SERVICE BULLETIN 94

SUBJECT: ELEVATOR HINGE BRACKETS (Part Number 552-4423-001)

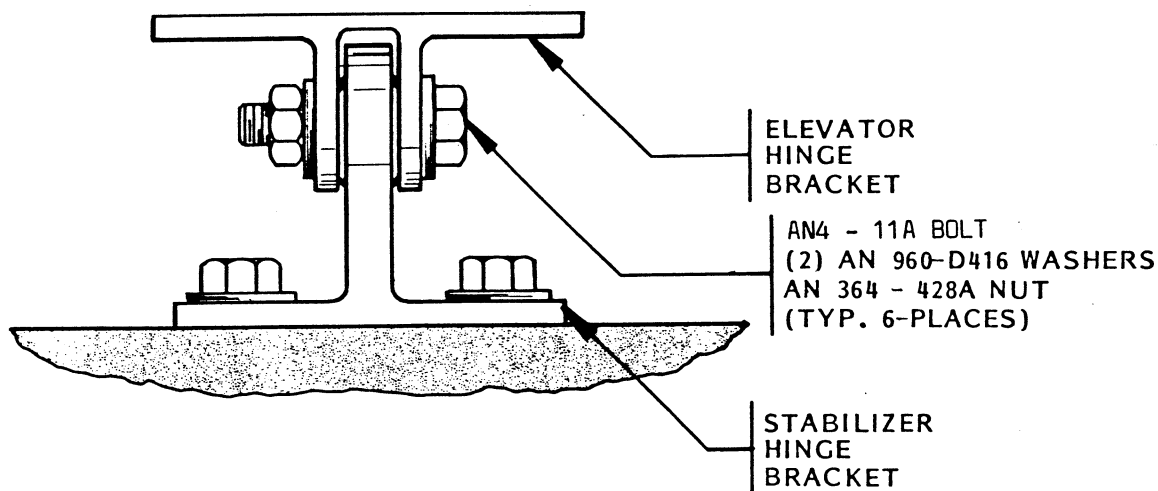
DESCRIPTION: One manufacturing run of Elevator Hinge Brackets was incorrectly produced with a 2-1/2" wide mounting surface rather than the normal 2-1/4" width. The resulting attach bolt hole pattern is 1/4" wider. Although this is not a problem structurally, the extra width could cause difficulty when installing the outboard hinge brackets.

SOLUTION: Use the 2-1/2" wide hinge brackets for the two inboard and two center hinge locations; exchange the two outboard hinge brackets for 2-1/4" wide brackets. Since the outboard hinge bracket location is very close to the outboard end of the elevator shearweb, the narrower hinge bracket provides additional space for installation of the counterweight arm shearweb.

If the elevator shearwebs have not yet been trimmed to within 1/8" of the beveled foam core in the counterweight arms, they may be left long enough to install the wider hinge brackets. This will position the counterweight arm shearwebs farther outboard, which is acceptable.
